**REQUEST FOR REVIEW AND COMMENT ON PROPOSED NEW FAÇADE AT
108 W 8th STREET – PRJ-155511/LUP-60502**

The city received a request for a proposed façade alterations at 108 W 8th Street. The site is located on the north side of 8th Street between Washington and Main Streets. The site is within Heritage Overlay District Number 2.

The proposal is to modify the existing façade to include a recessed entry, new canopy, additional glass and a repaint the façade to Navy Blue with yellow and natural exposed wood accents. The applicant also proposes a projecting sign at the main entrance.

DESIGN REVIEW - PROPOSED FRONT ELEVATION
1/4" = 1'-0"

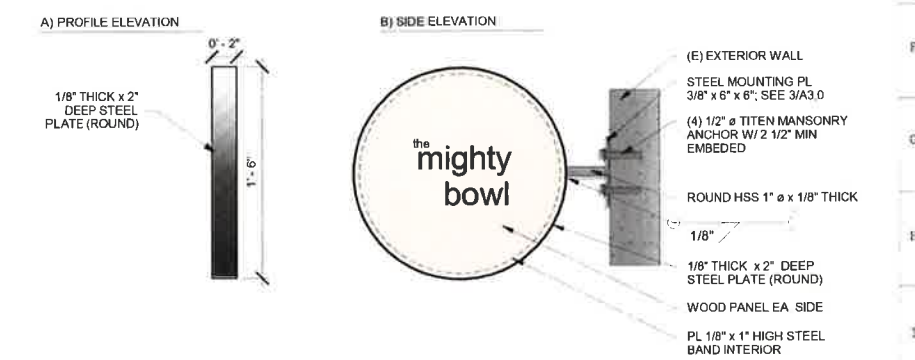
Finding: Revisions to Area 1 are minor; consisting of paint and a “planted wall”. Area 2 is proposed to remove the existing door and entry and replace it with storefront glazing. Area 3 is to be the entrance, with storefront windows and door. This is to be recessed, providing a sheltered outdoor area.

Area 4 is to retain the existing door and provide additional interest with windows and wood siding.

Finding: The applicant proposes a canopy in all four sections. The canopy will be metal with exposed wood visible on the underside of the canopy sections.

Finding: The building is currently painted beige in Areas 2 through 4. Area 1 is painted blue and green. The window will be storefront type. The proposed colors are blue with natural wood and yellow accents.

Finding: This is a non-listed building. The rendering indicate a combination of navy blue paint with yellow accents and metal and natural wood.

Finding: The cornice lines will not be changed. The upper portion of the building will not be structurally altered. The proposed yellow trim line below the cornice will accentuate it.

MIGHTY BOWL SIGN DETAILS
1 1/2" = 1'-0"

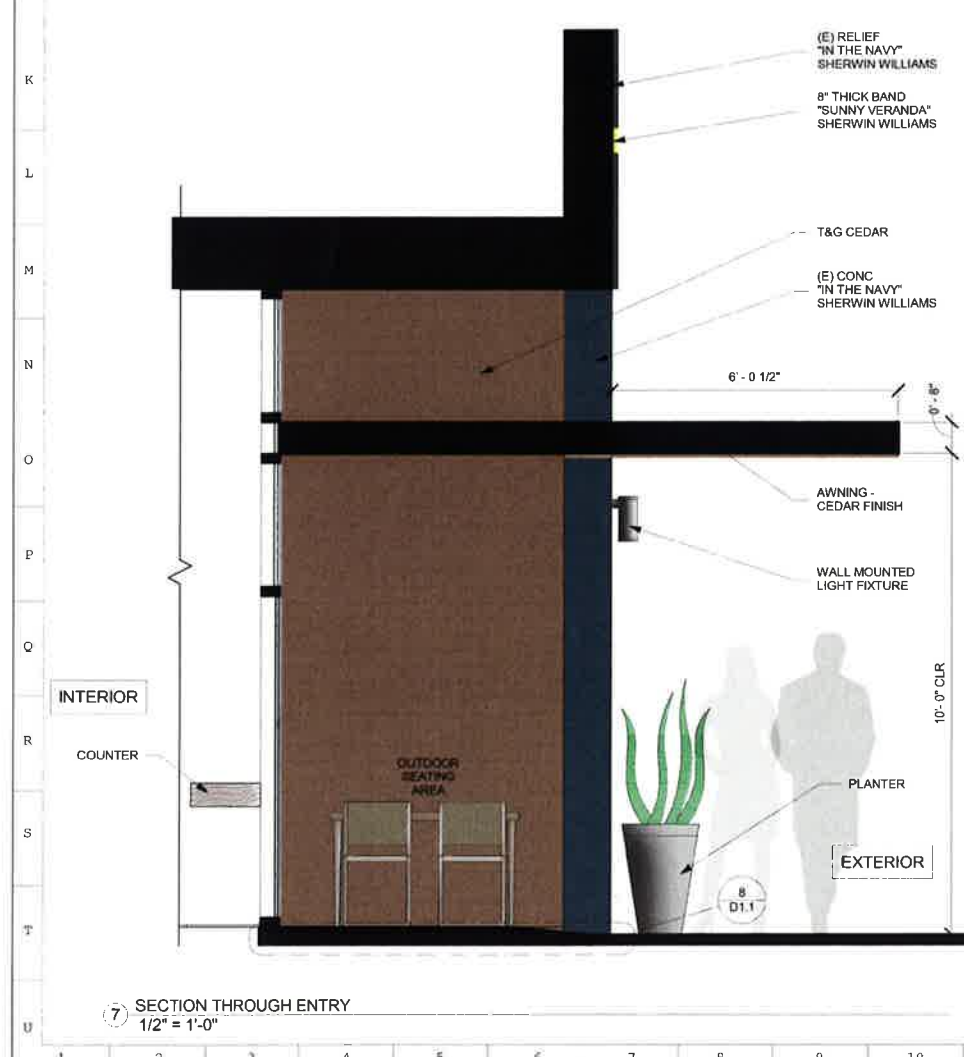
The applicant proposes to install windows and an entrance along the façade. A 1½ foot diameter, circular projecting sign is proposed to the west of the main entrance. This is to be a two-sided, wood paneled sign.
